**PHASE TWO DEVELOPMENT
TUNXIS COMMUNITY COLLEGE
FARMINGTON, CONNECTICUT
PROJECT: BI- CTC - 426**

BID OPENING	1:00 P.M.	JUNE 22, 2011
ADDENDUM NUMBER ONE	DATE OF ADDENDUM	JUNE 14, 2011

PROJECT TUNXIS COMMUNITY COLLEGE SKETCH NUMBER SKM-060211.1
 PROJECT NUMBER 0903 DATE 06/02/2011 REVISION TO SHEET NUMBER M3.1

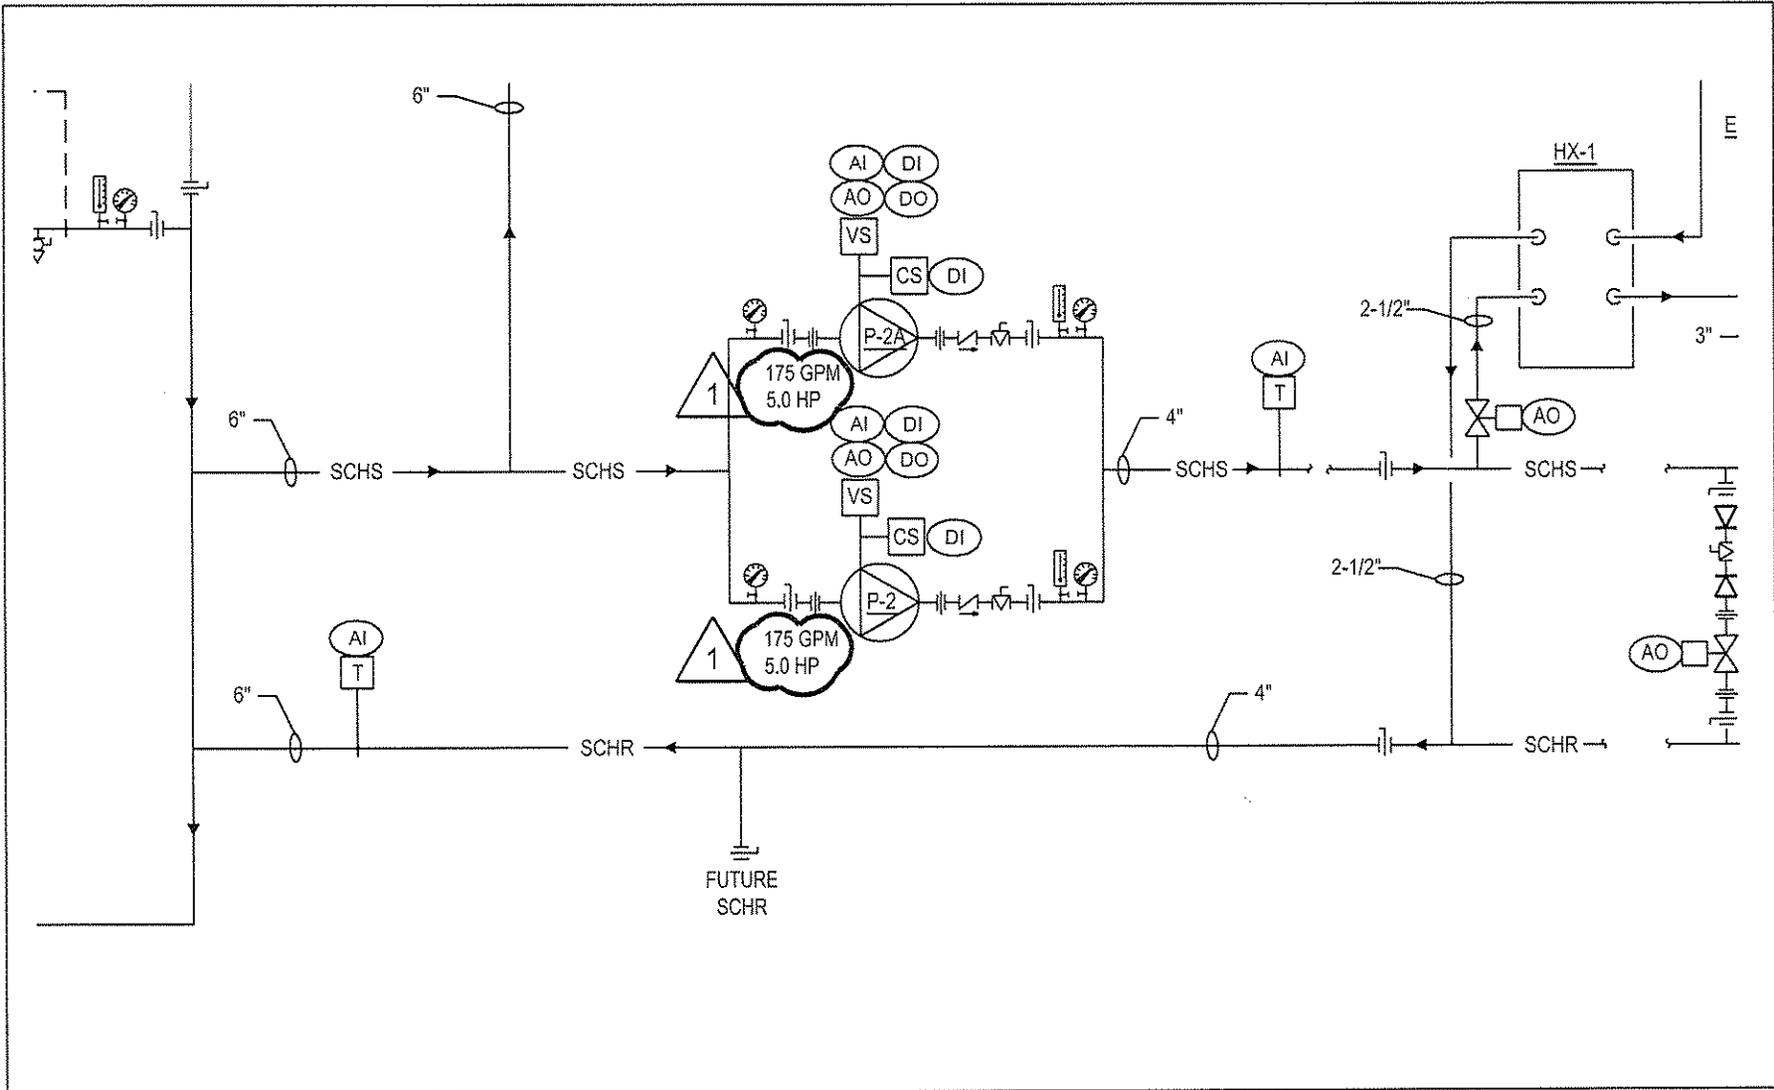
- a. Pump Schedule – at P2 and P2A, **Change** 30 Head Ft To 40 Head Ft as indicated on Sketch Number SKM-060211.1.
- b. Pump Schedule – at P2 and P2A, **Change** 2.23 Max BHP To 3.11 Max BHP as indicated on Sketch Number SKM-060211.1.
- c. Pump Schedule – at P2 and P2A, **Change** 3.0 HP To 5.0 HP as indicated on Sketch Number SKM-060211.1.
- d. Pump Schedule – at P4 and P4A, **Change** 30 Head Ft To 40 Head Ft as indicated on Sketch Number SKM-060211.1.
- e. Pump Schedule – at P4 and P4A, **Change** 1.37 Max BHP To 1.95 Max BHP as indicated on Sketch Number SKM-060211.1.
- f. Pump Schedule – at P4 and P4A, **Change** 1.5 HP To 2.0 HP as indicated on Sketch Number SKM-060211.1.

PROJECT TUNXIS COMMUNITY COLLEGE SKETCH NUMBER SKM-060211.2
 PROJECT NUMBER 0903 DATE 06/02/2011 REVISION TO SHEET NUMBER M0.2

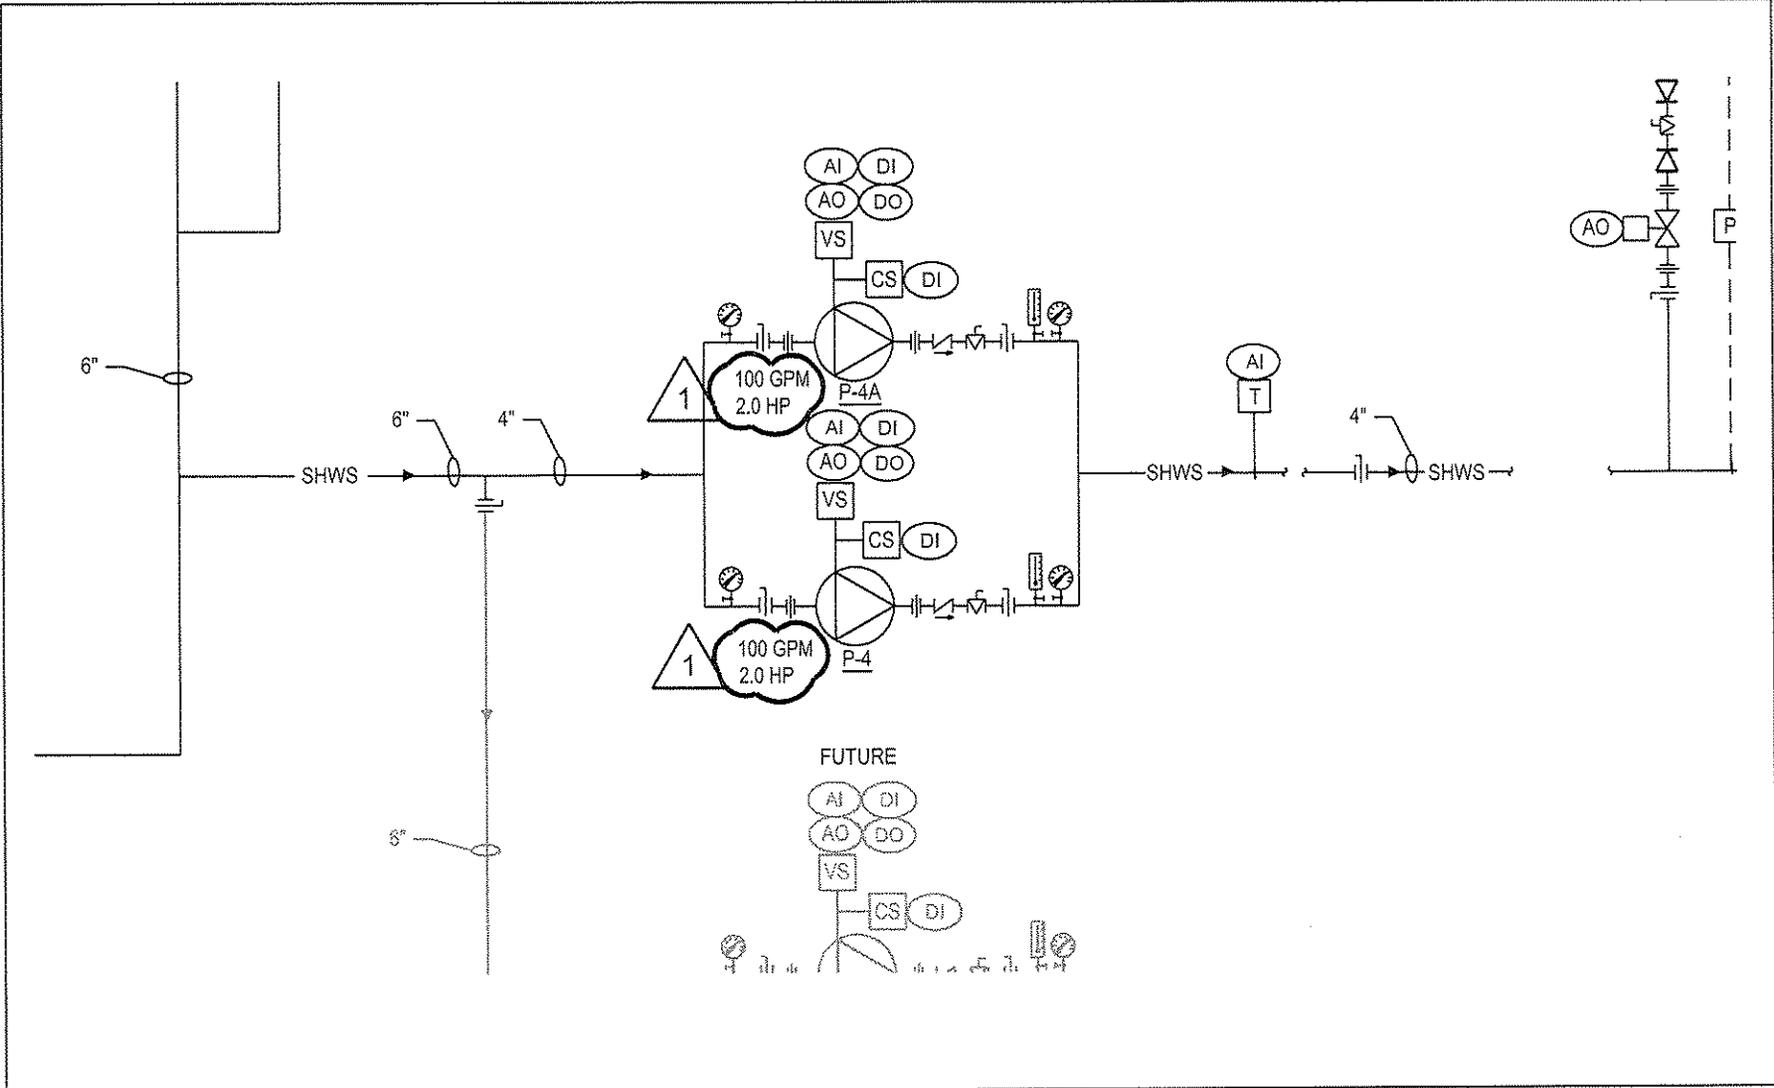
Detail 1 – Chilled Water Control Diagram – at P2 and P2A, **Change** 3.0 HP To 5.0 HP as indicated on Sketch Number SKM-060211.2
